RICOH	Technical Bulletin	No. RTB-001

SUBJECT: Software Modification	DATE: Nov. 30, '94 PAGE: 1 of 1
PREPARED BY: S. Hizen CHECKED BY: S. Hamano	FROM: 2nd Technical Support Section

RICOH	**Technical Bulletin**	**No. RTB-003**
SUBJECT: Energy Star		DATE:September 30, '95 PAGE:1 of 6
PREPARED BY: N. Kaiya CHECKED BY: M. Iwasa	FROM: 2nd Technical Support Section	
CLASSIFICATION: ☐ Action Required ☐ Troubleshooting ☐ Retrofit Information ■ Revision of service manual ☐ Information only ☐ Other		MODEL: Ibis -10, -15, -17 only

This RTB explains the modifications made to meet the Energy Star specifications. With this modification, to save energy consumption, the copier automatically turns off 30 minutes after the last copying job has been completed.

Auto Off Mode

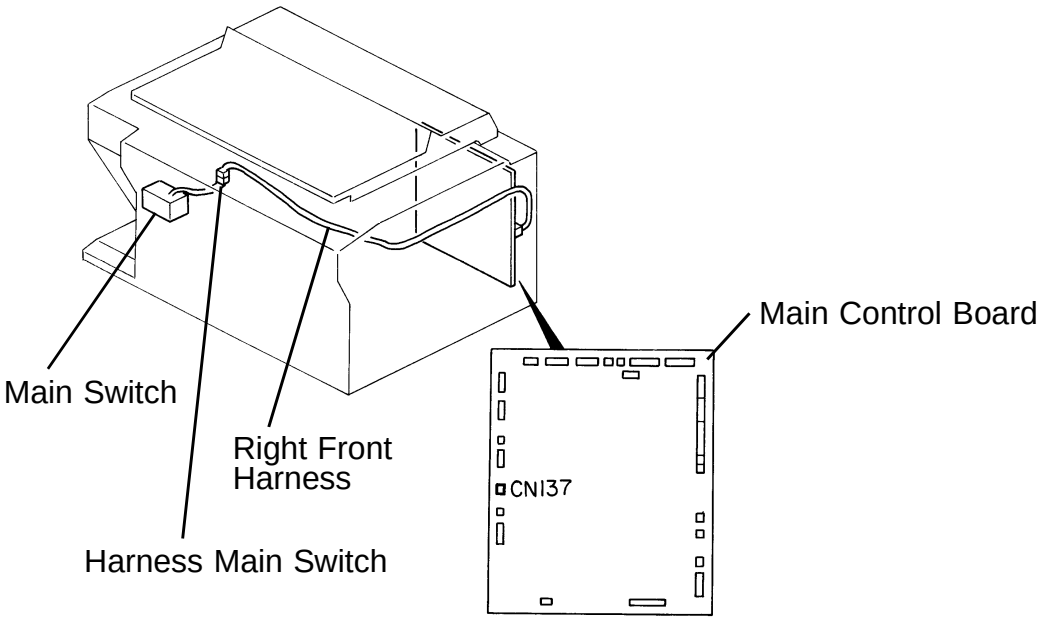
To automatically turn off the copier, a new type of main switch with an incorporated coil is used. When the CPU drops CN137-1 from +24V to 0, the main switch contact is opened. The P to P wiring diagram and connector layout are shown below.

Anti - Condensation Heater

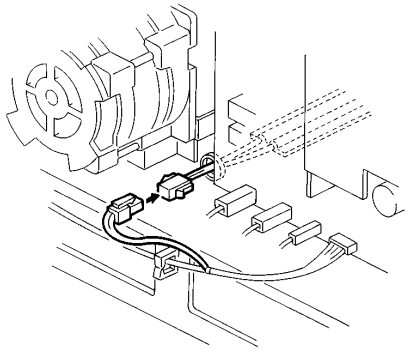
To meet a very strict specification for power comsumption in auto off mode, drum anti-condensation heater connector is kept disconnected at the factory. So, at the installation, please check the humidity conditions at the customer site and set the heater connector if necessary.

The anticondensation heater connector can be found at the rear of the machine, next to the main drive motor. Remove the rear cover and locate the unplugged red connectors. Caution: Unplug the copier power cord before starting this procedure.

Sorter

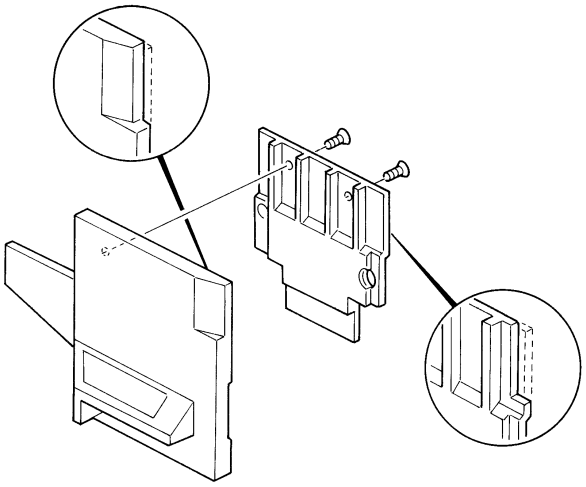
The opening on the left lower cover for the main switch has been extended. It is necessary to use the new cover for the Energy Star copiers. When using a new cover on a old machine, it is necessary to attach the cover switch decal to the switch bracket next to the main switch in order to cover the opening of the new left lower cover.

The new main switch is larger than the old switch. When a sorter is installed on the copier, the main switch may interfere with the top right corner of the sorter cover. To prevent this, the sorter cover and sorter support cover have been modified from the following serial numbers. The old sorter can be used for other models or Ibis copiers before Energy Star modification.

S/N	A490 - 17:	2605040001 ~
	A490 - 25:	1965040001 ~
	A490 - 26:	3F00450001 ~
